**DESIGN REVIEW AND PRESERVATION BOARD  
SACRAMENTO, CALIFORNIA  
MEMBERS IN SESSION:**

**ITEM NO. 4  
June 15, 2005**

**DR04-309**

**THE TOWERS ON CAPITOL MALL- PROPOSED  
MIXED USE RESIDENTIAL, HOTEL, AND RETAIL  
DEVELOPMENT**

FIRST FLOOR PLAN 1/40" = 1'-0"

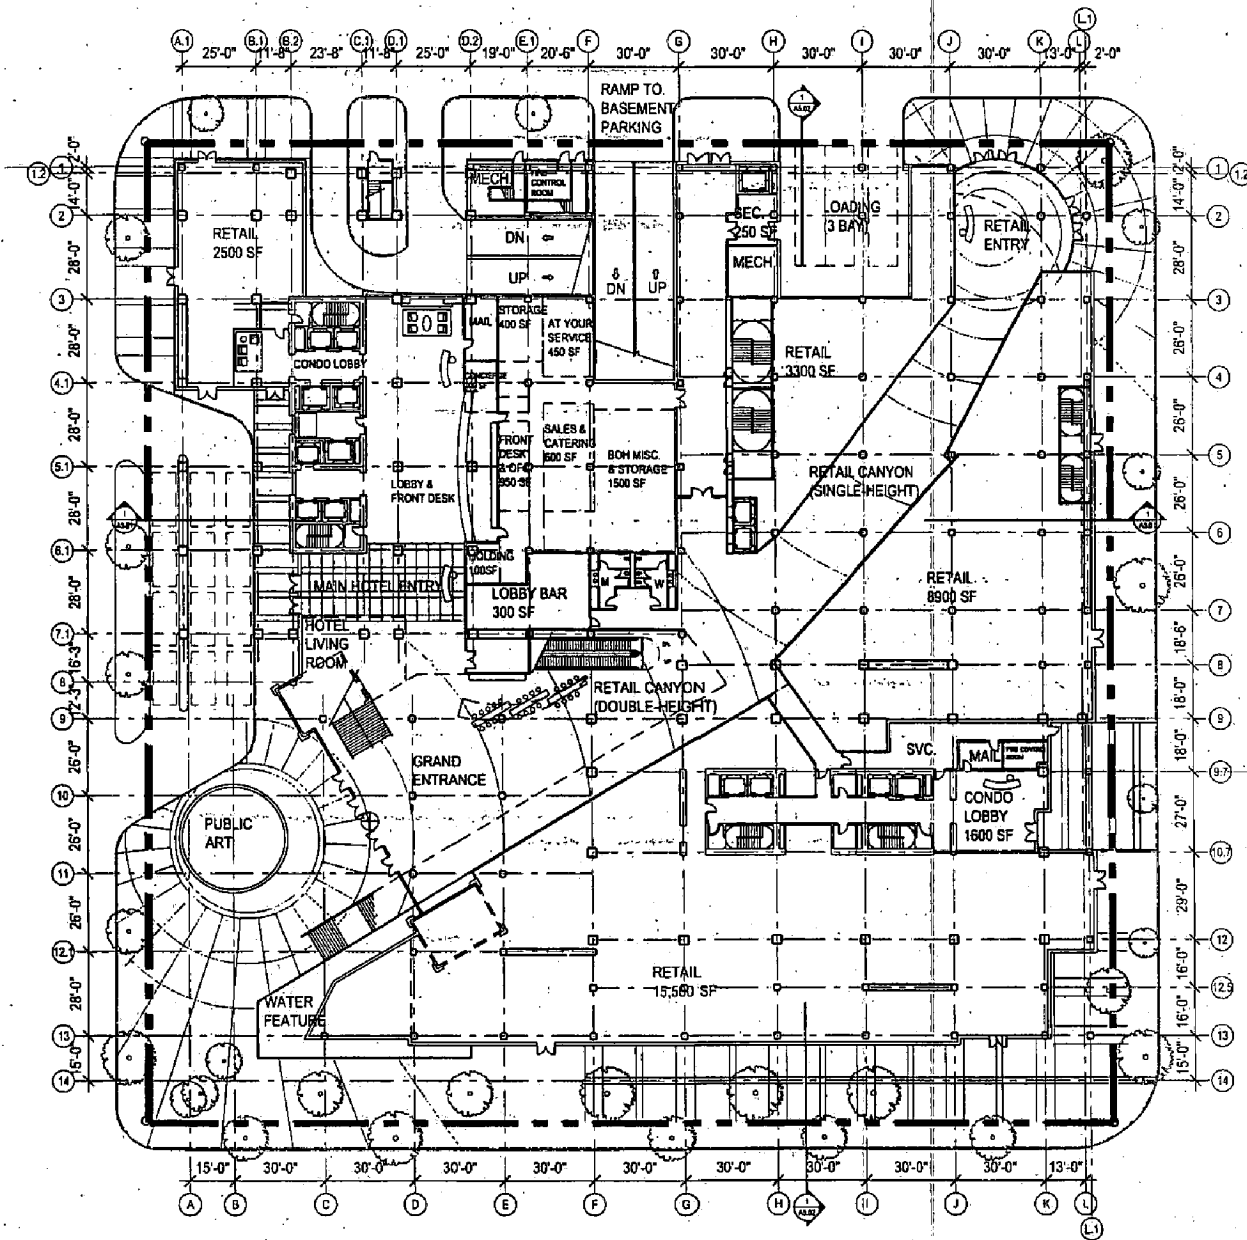
and L Street. (See first floor exhibit) There will be retail storefronts on all four sides of the building, but predominantly on 4<sup>th</sup> Street and the Capitol Mall.

5. **Main Building Entries:** There are retail spaces and entries available on each side of the building (see First Floor exhibit). The primary entryway for the hotel is on the west side of the building along 3<sup>rd</sup> Street. The corner of 3<sup>rd</sup> Street and Capitol Mall is the primary entryway for the retail canyon. The entry consists of a large public plaza space and a staircase that will take visitors from the street up to the second floor of the podium to additional retail and hotel uses. The exhibits indicate that the applicant plans to include public art and a water feature at this location. ~~Staff has requested a landscape plan that includes further details about the plaza area.~~
